PROJECT NAME: SW 100TH STREET PUD - EAST

PROJECT NUMBER: 2021080035

APPLICATION: IMPROVEMENT PLAN #30222

REVIEW ITEM: Improvement Plan

IRRIGATION PLAN - NW
 SW 100th STREET PUD - EAST
 MARION COUNTY FLORIDA

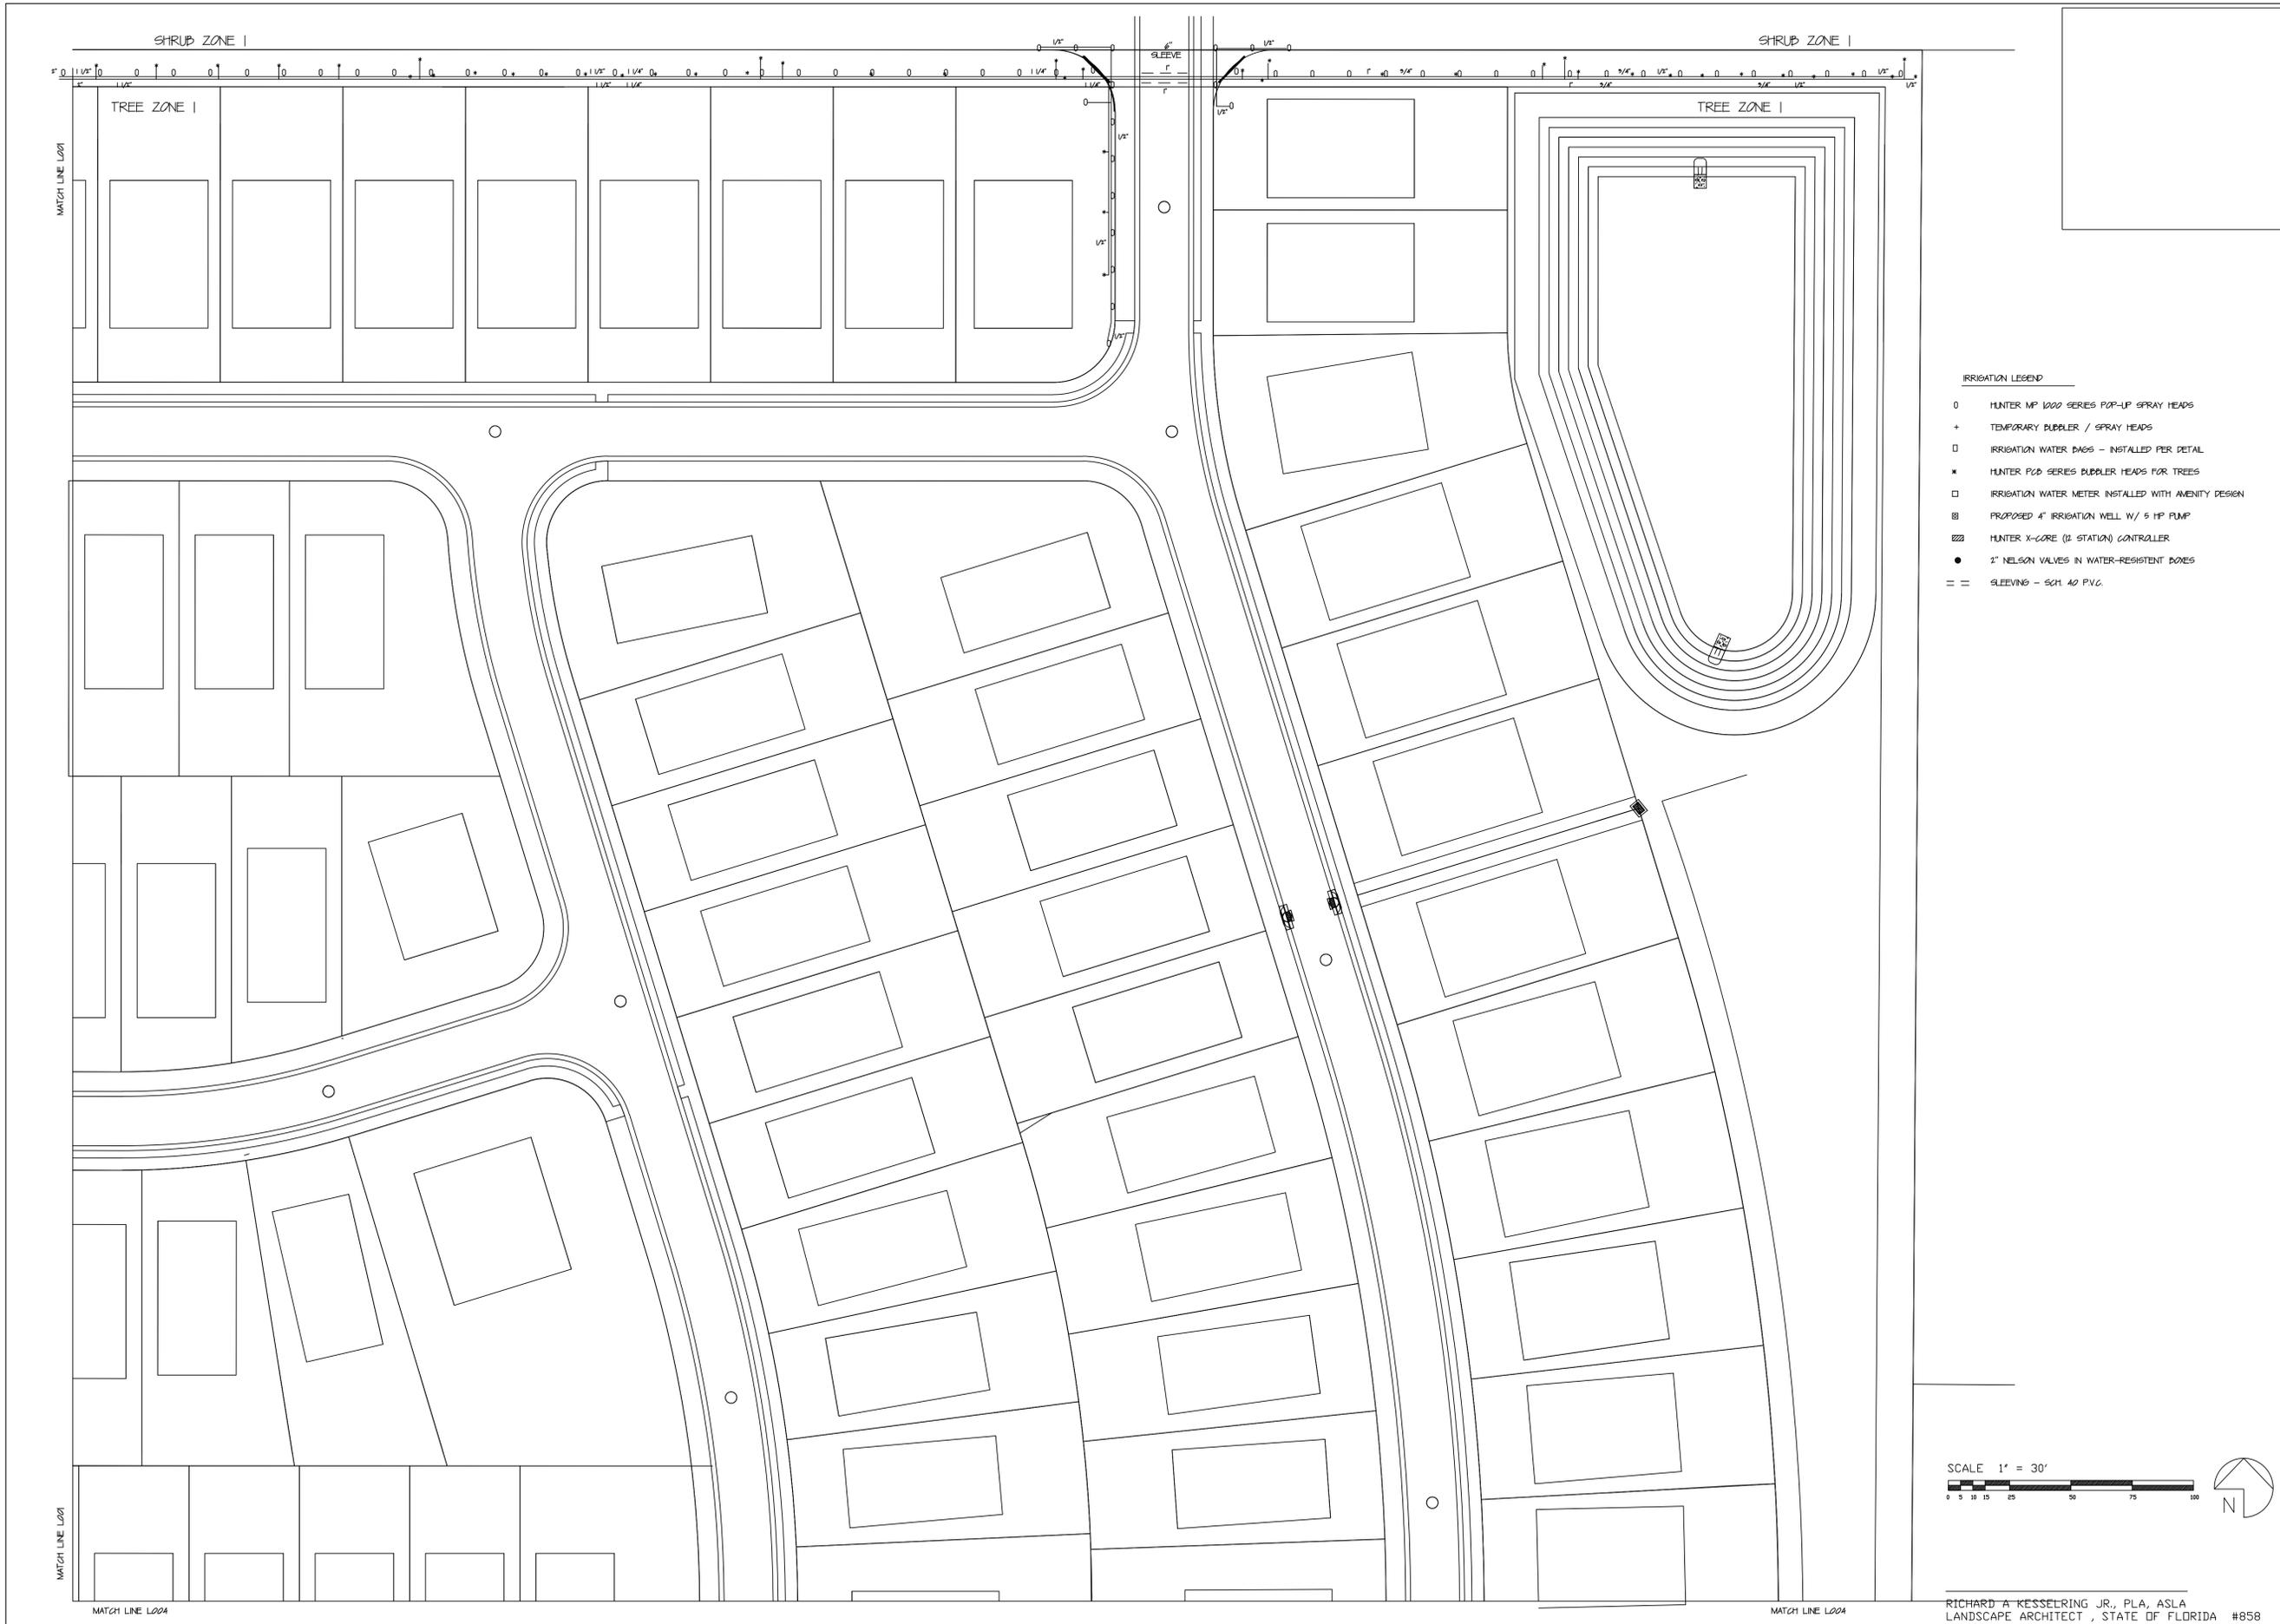
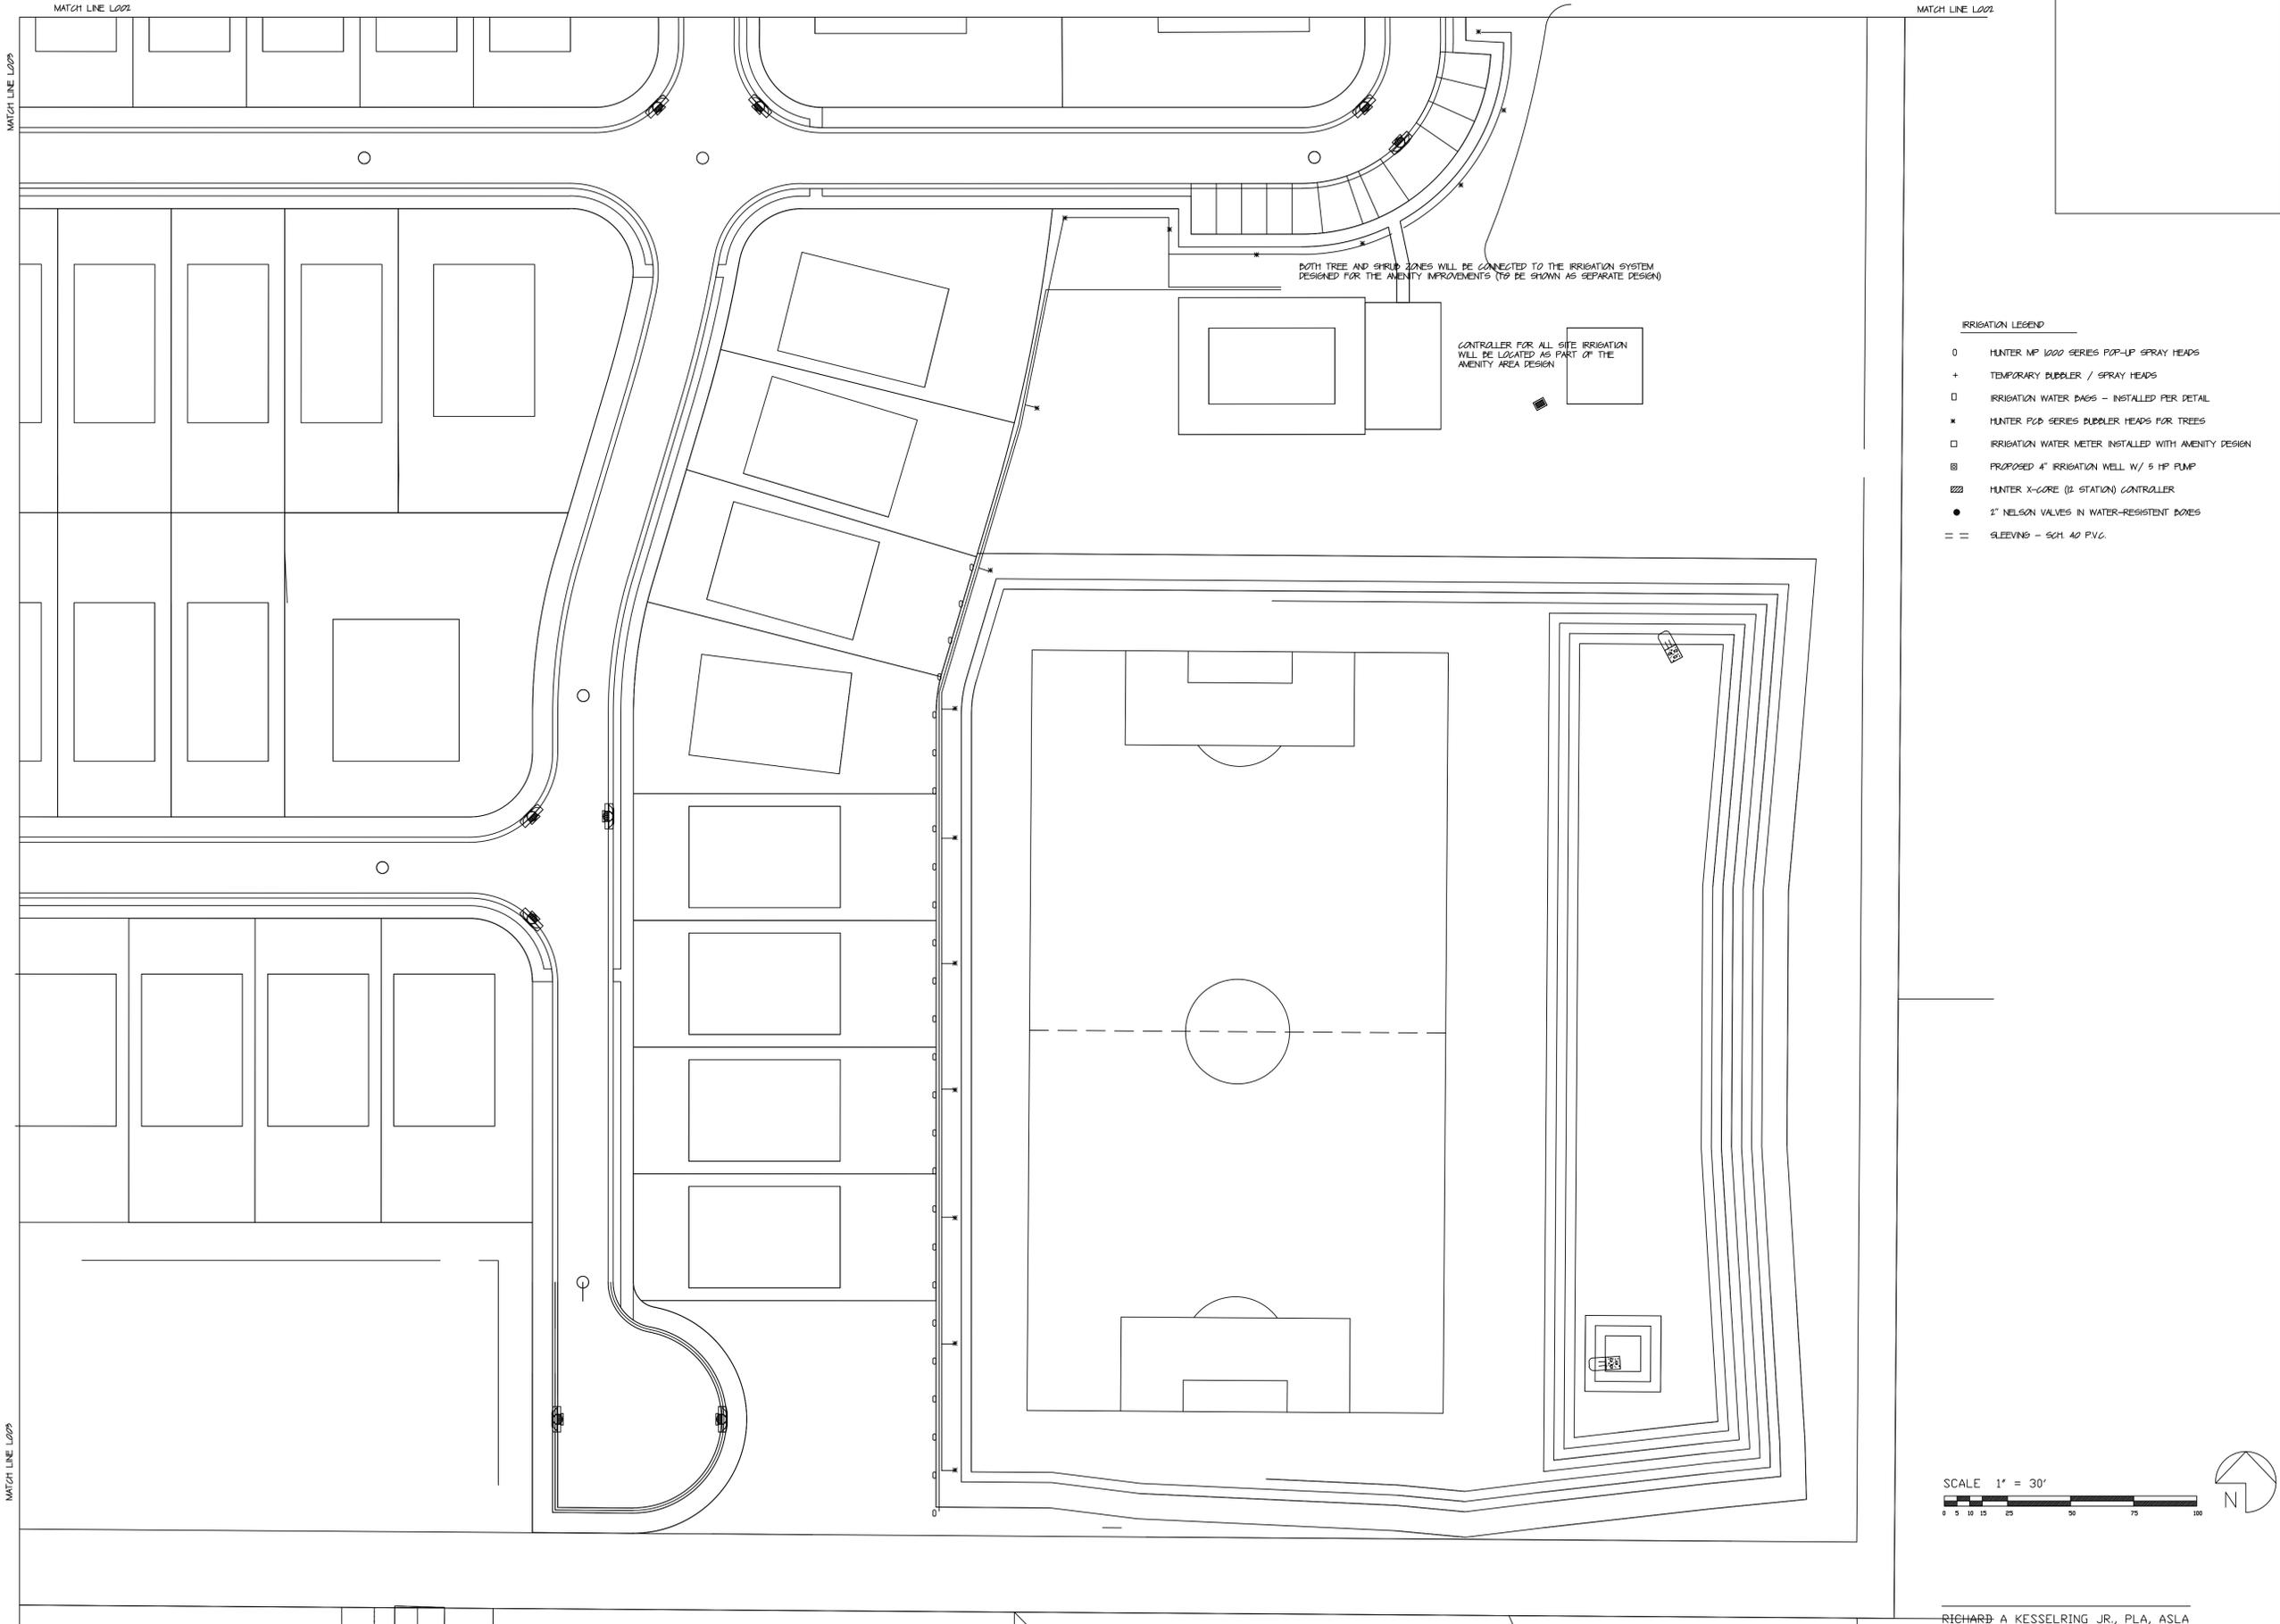
- 25 DEPARTMENT: LSCAPE - LANDSCAPE DESIGN AND IRRIGATION
REVIEW ITEM: 6.9.3 - Irrigation design standards
STATUS OF REVIEW: NO
REMARKS: Plan states irrigation is only until establishment, irrigation system should be permanently installed.
